| marantz® SERVICE BULLETIN | | Date: 28-Dec-2004 | Model: SR7400/SR7500/SR8500 |
| | | Page: 1 / 1 | REF.NBR: MZ04-085 |
| | | Subject: FL Display does not light up. | |

SR7400

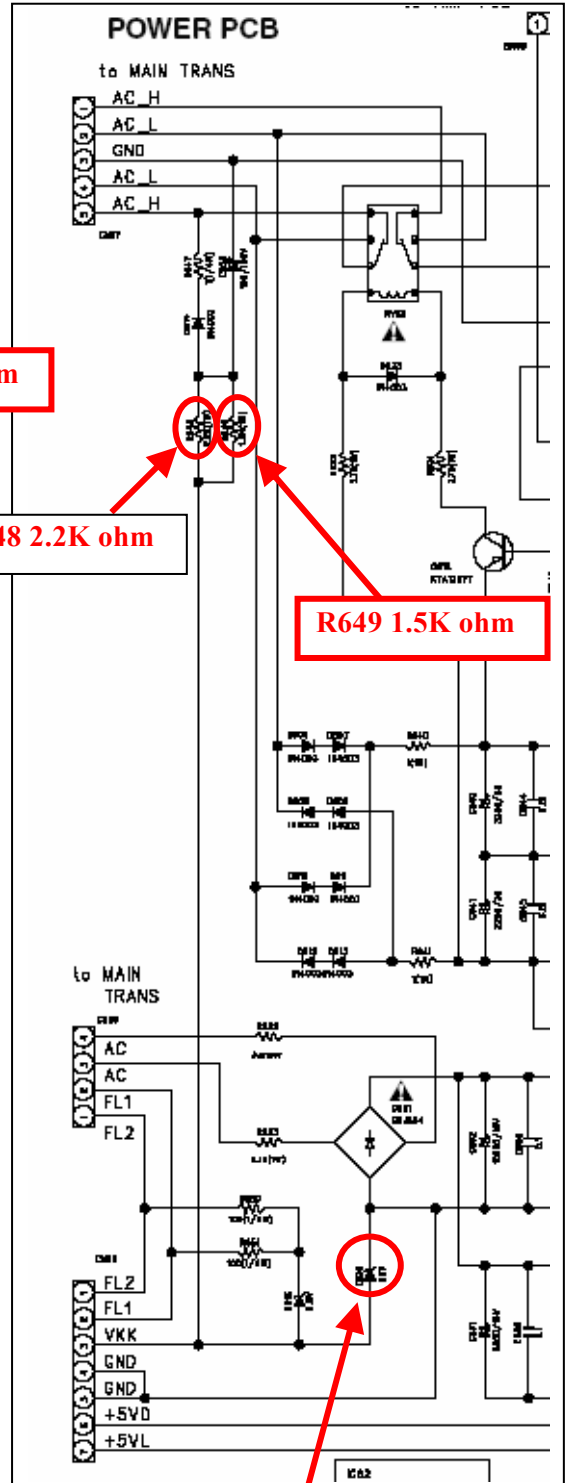
1. In condition, AC input is about 10% overvoltage than Rated voltage and the sound is not outputted for a long time.
2. The DIODE (POS NO.D616) may short-circuit. R648 and R649 are broken by this short-circuit.

D616 Zener Diode part no. 90M-HD302190R

1. POS.NO **R649** RESISTOR (**1.5K OHM**) is changed to RESISTOR(**2.2K OHM**) on the POWER PCB

SR7500 / SR8500

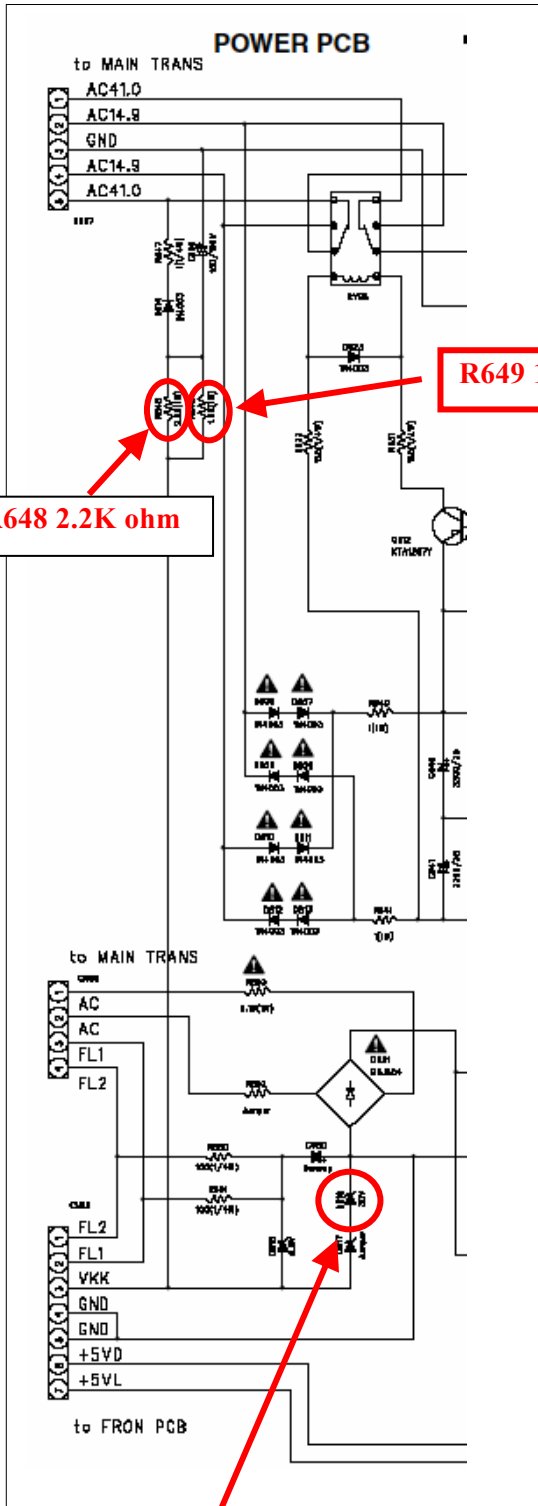
D616 Zener Diode part no. 90M-HD302190R
